PURCHASING

MEMO TO: Prospective Bidders

SUBJECT: **Addendum #4:** Locks Creek Drainage Improvements

CITY OF FAYETTEVILLE -
LOCKS CREEK DRAINAGE IMPROVEMENTS

REVISIONS:
1 - 5/4/26
REV. WATER MAIN
DESIGN

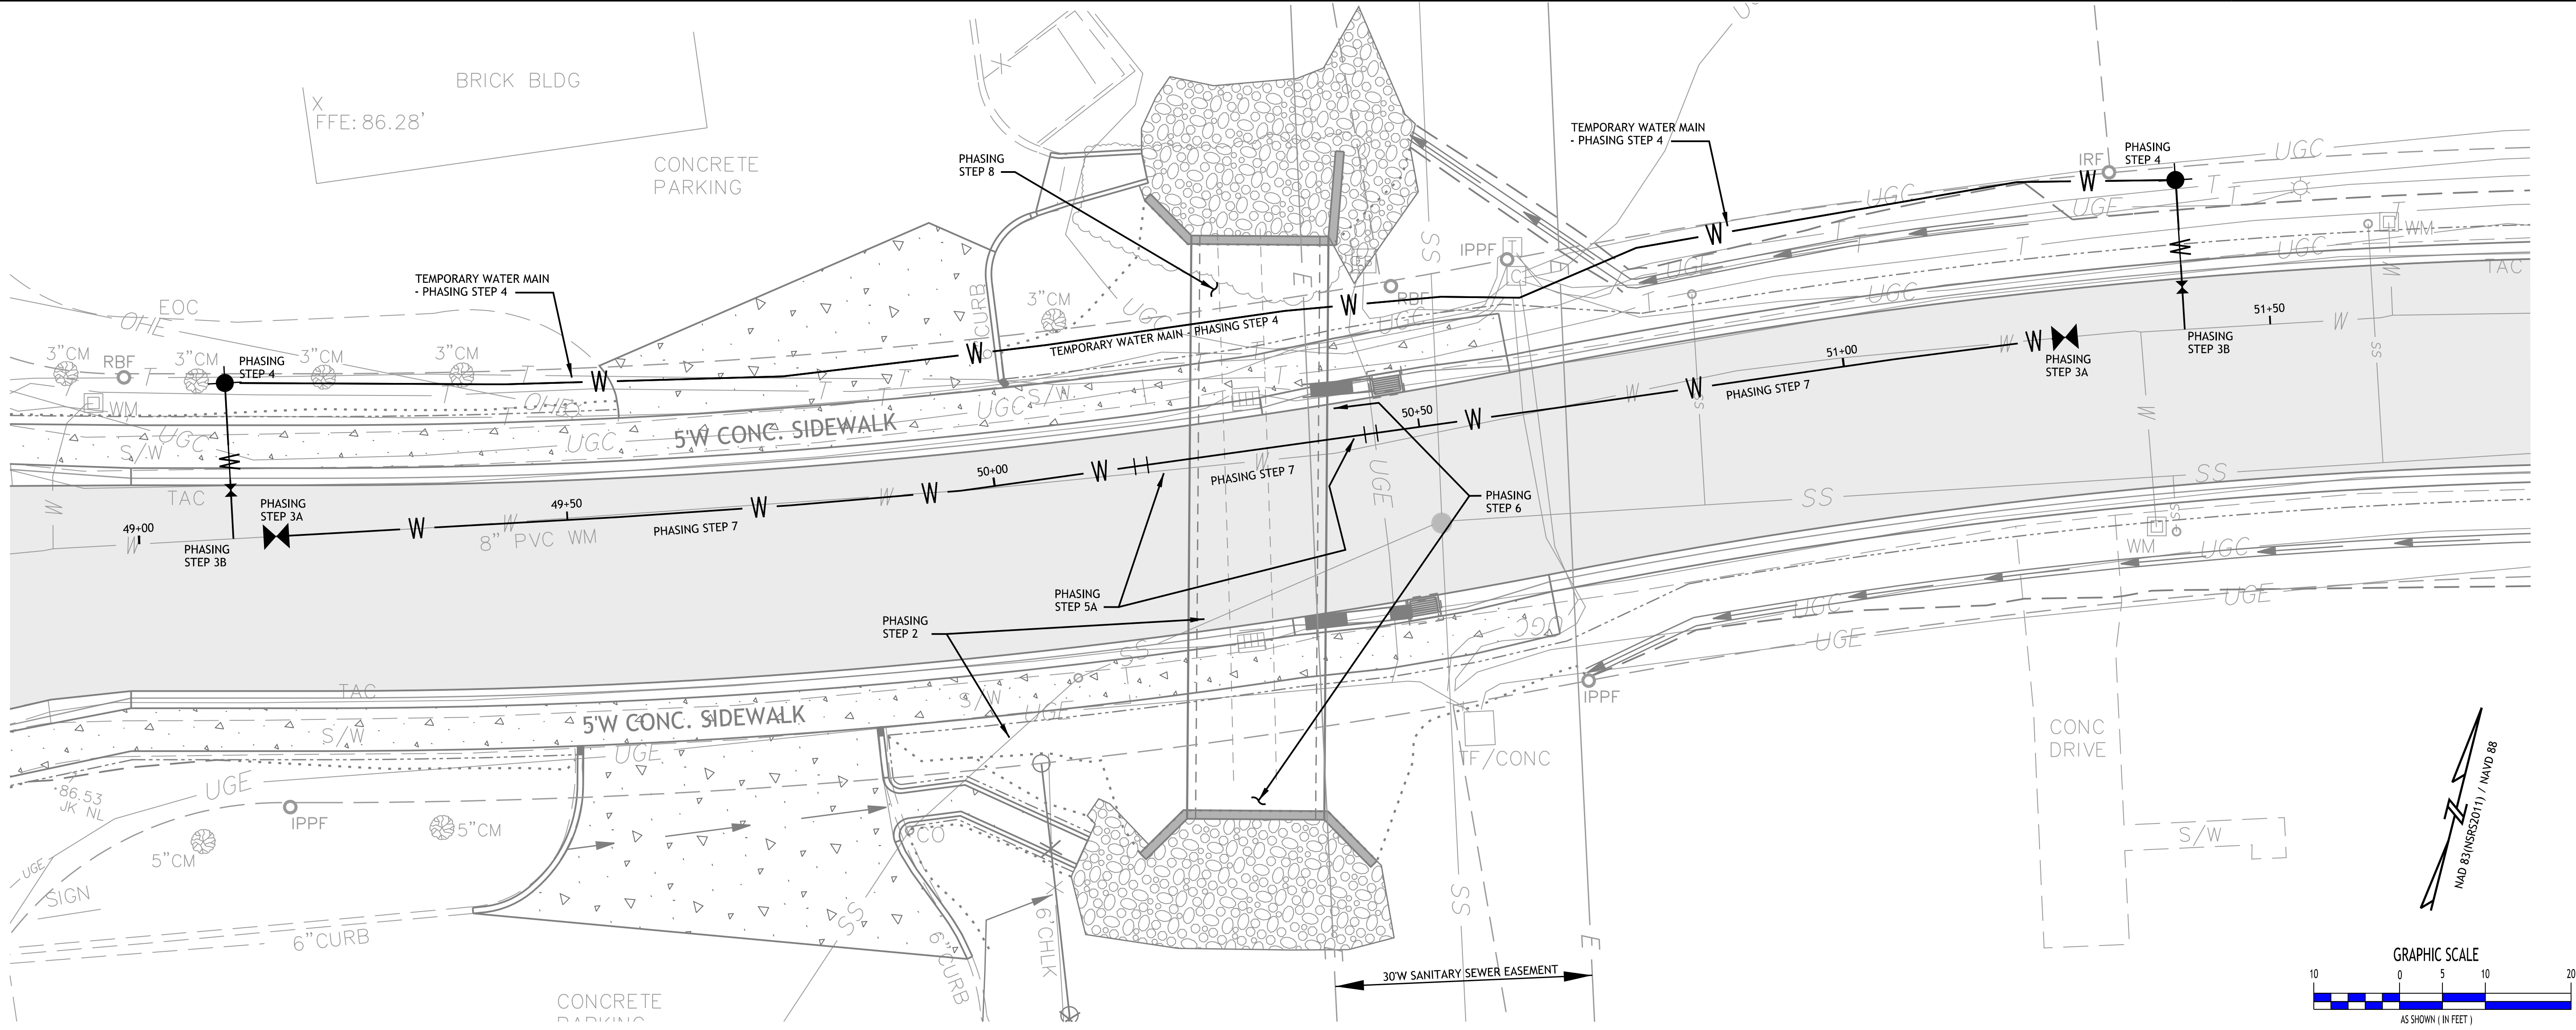
- i. CU-01 with revised water main design
- ii. CU-02 with revised water main design
- iii. CU-02A showing temporary water main bypass
- iv. CU-03 referencing updated construction sequencing on other sheets
- v. DT-04 – construction detail sheet with addition of fire hydrant assembly
